APPLICATION FOR A CERTIFICATE OF APPROPRIATENESS – STAFF REPORT

COA-0017-2019 526 EUCLID STREET

Nature of Project: Construct addition; construct retaining wall

526 Euclid St - Existing Driveway Side Elevation

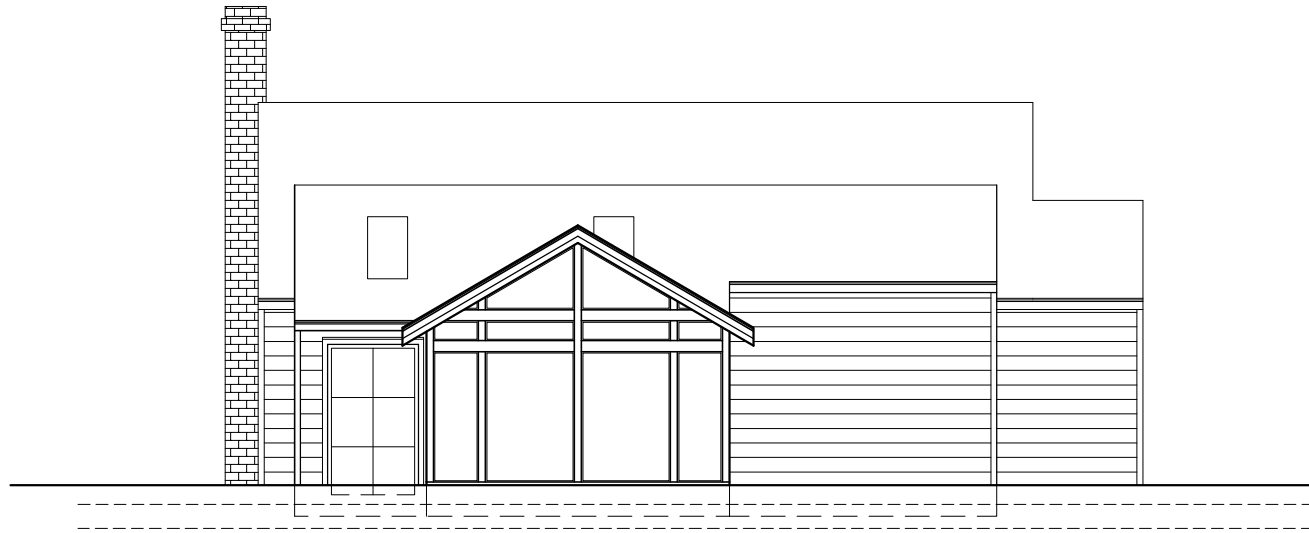
- 10* Two new low-profile skylights are proposed in the addition. Specifications were provided.
- 11* An elevation for the proposed driveway side was not included.

- Tree survey identifying the locations and species of trees greater than 8" DBH;
- Tree protection plan prepared by an arborist certified by the International Society of Arboriculture (ISA) or by a North Carolina licensed landscape architect that addresses the critical root zones and provides staging areas for construction activity and material storage is provided;
- Grading plan;
- Retaining wall;
- Driveway side elevation.

PROPERTY OF:
LOUIS J. & SARA E. PASCUCCI
LOT 120
PINS: 1704.20-91-5507

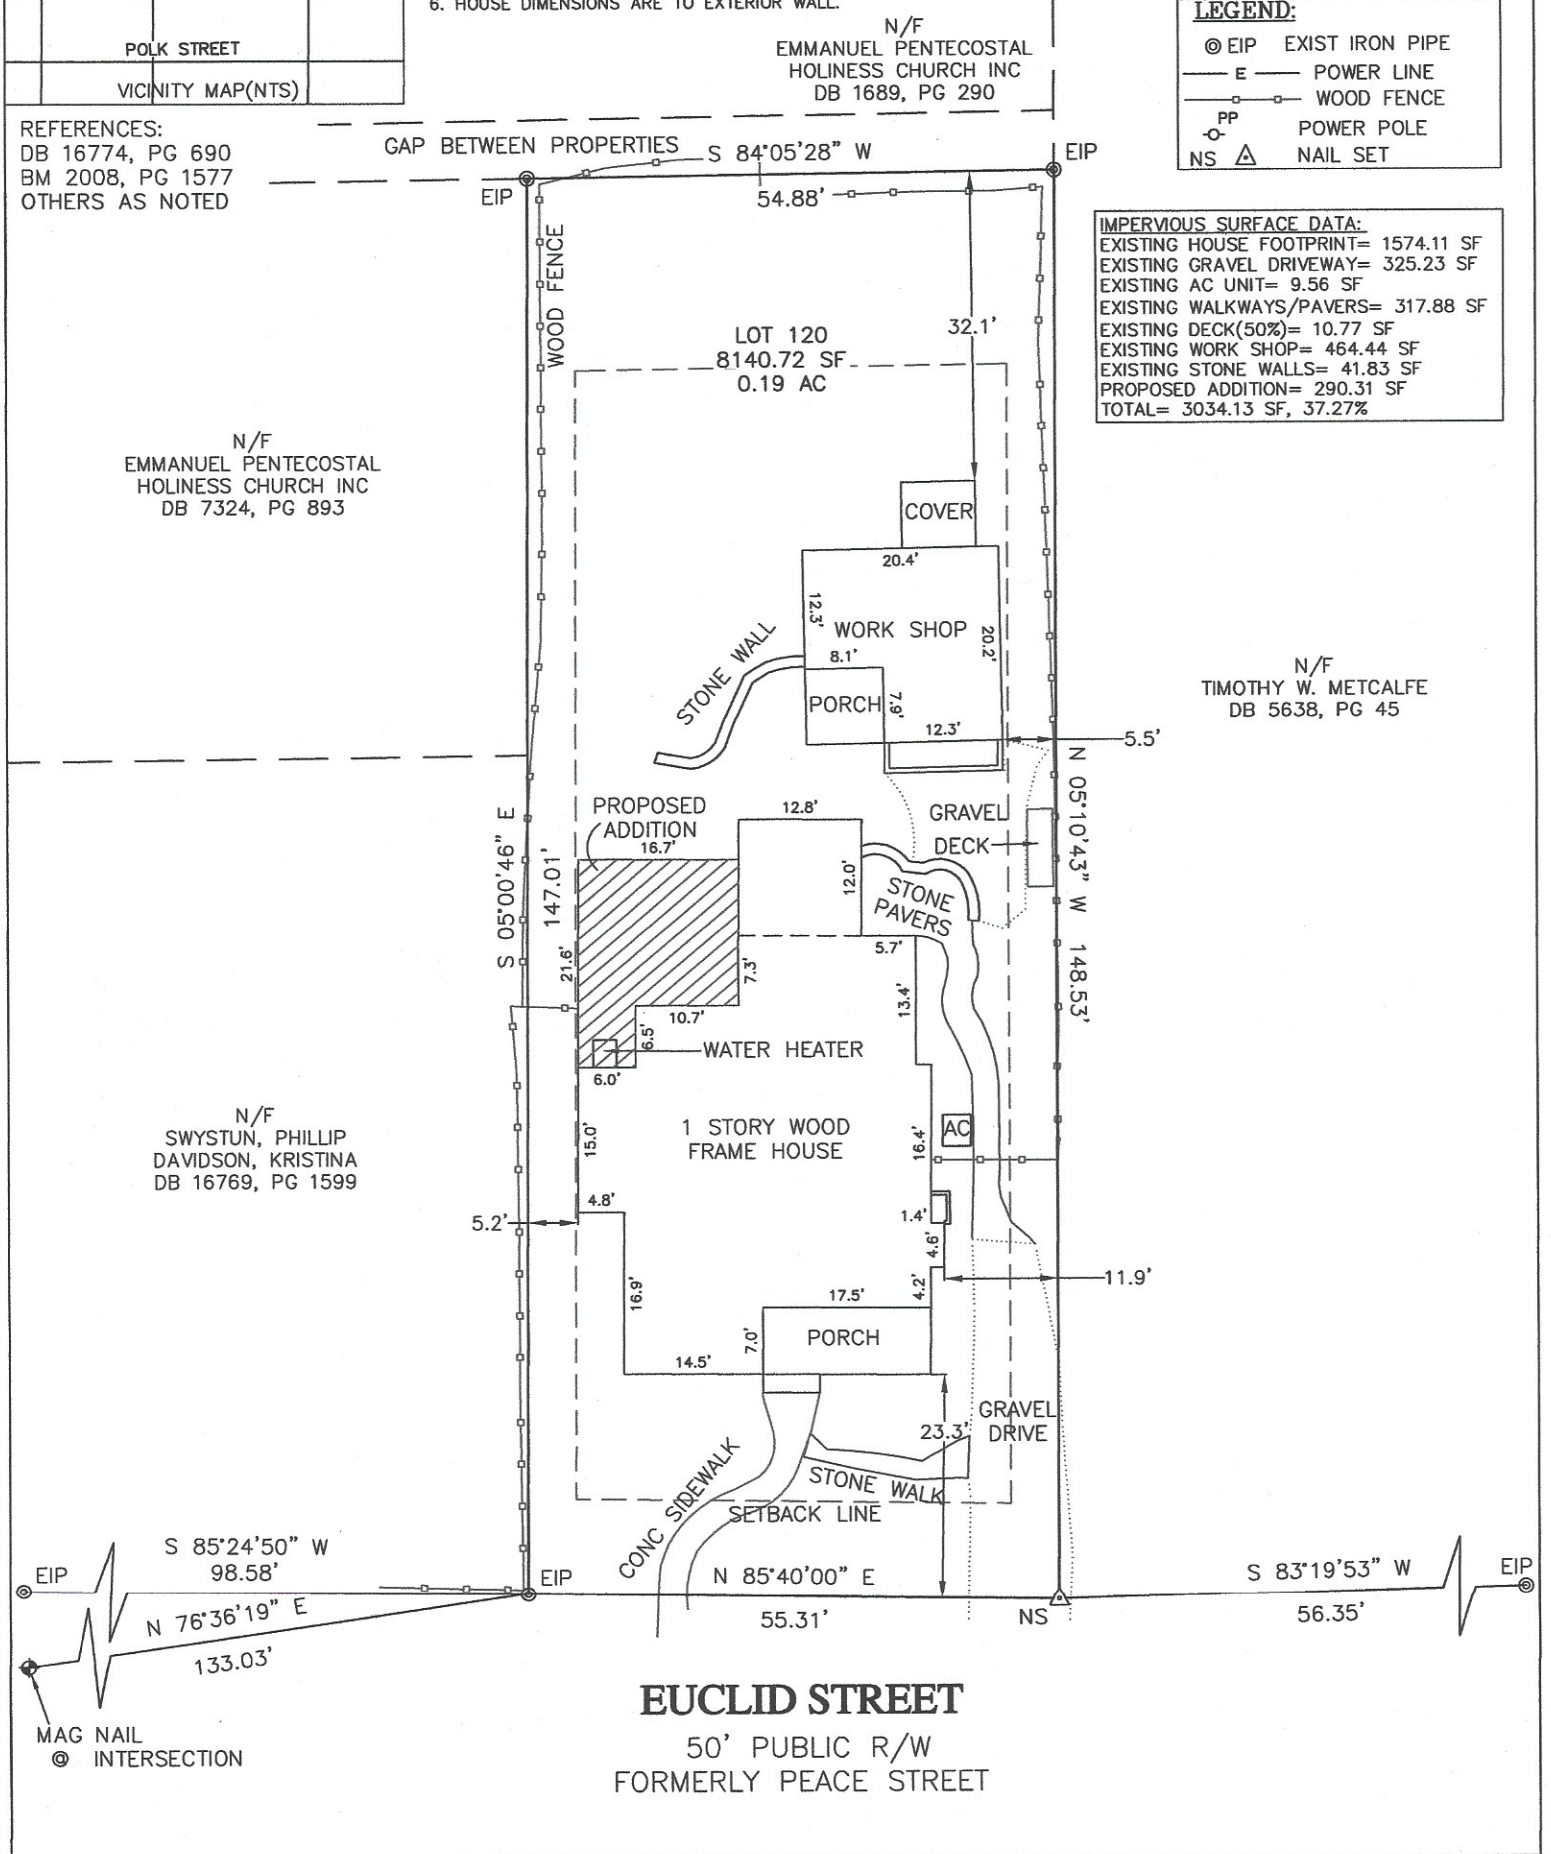
- 3* The application states that the rear yard will require grading where the addition is proposed to be construction. No details were provided on the extent of grading beyond the footprint of the addition.

- 4* A retaining wall is proposed for the rear yard. No drawings or details were provided on the retaining wall.
- 5* **Built mass to open space analysis:** According to the applicant, the lot is 7,971 SF. Sanborn maps from 1914-1950 show approximately 1,599 SF of built area on a 13,416 SF lot, with a ratio of built area to open space of 12%. The existing built area is 2,231 SF, with a ratio of built area to open space of 27%. The proposed built area is 2,360 SF, with a ratio of built area to open space of 29%.

12* The application states an arborist will be engaged to provide a tree protection plan. No tree protection plan was provided in the application materials nor were the locations of trees identified.

526 Euclid St - New Roof Plan

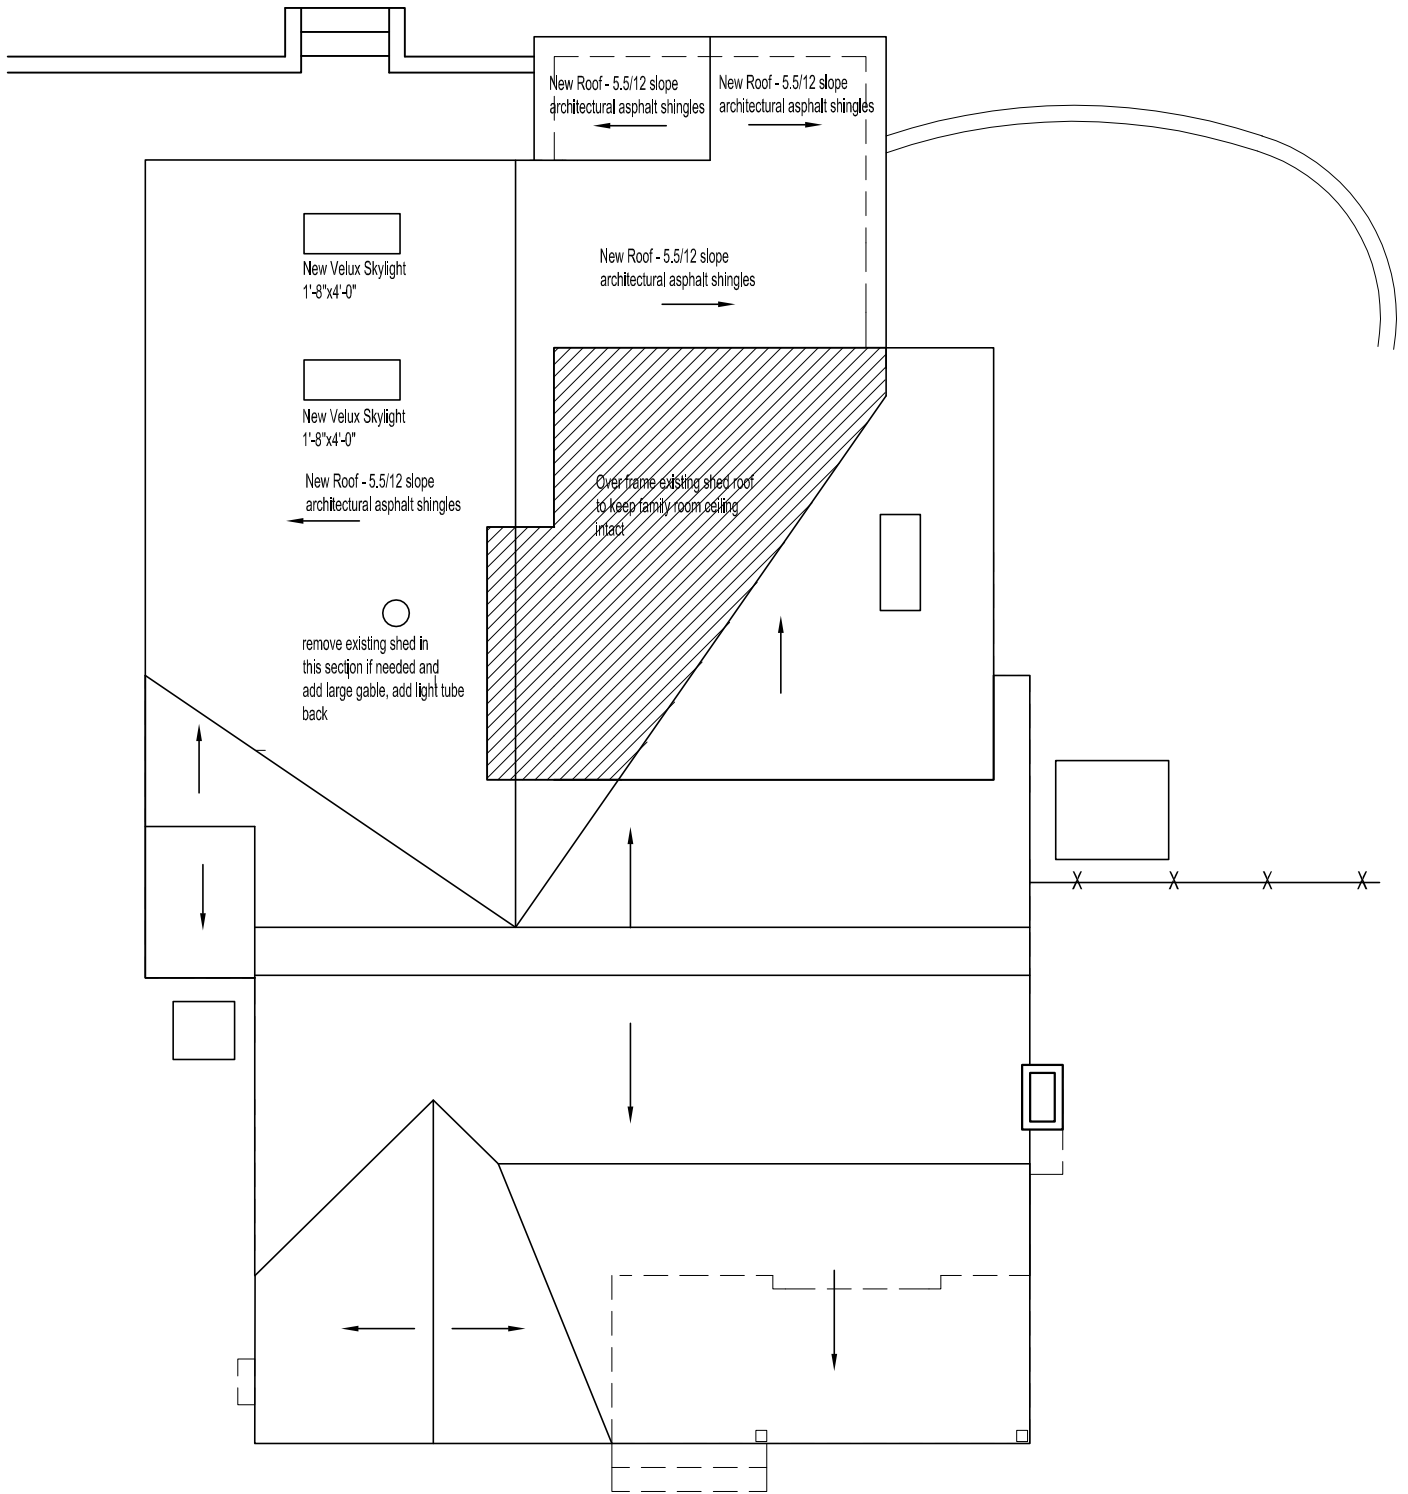
- 7* The existing roof is a side-gable form with shed roof porch and a shed roof addition with cross gable screened porch on the rear. There are no eaves.

- 8* The proposed addition over-frames the existing rear roof as an extended cross-gable. 6” eaves are proposed. Details were not provided.
- 9* Three 6-pane wood casement windows are proposed for the rear façade. These windows appear to match the existing rear façade window. Specifications were provided.
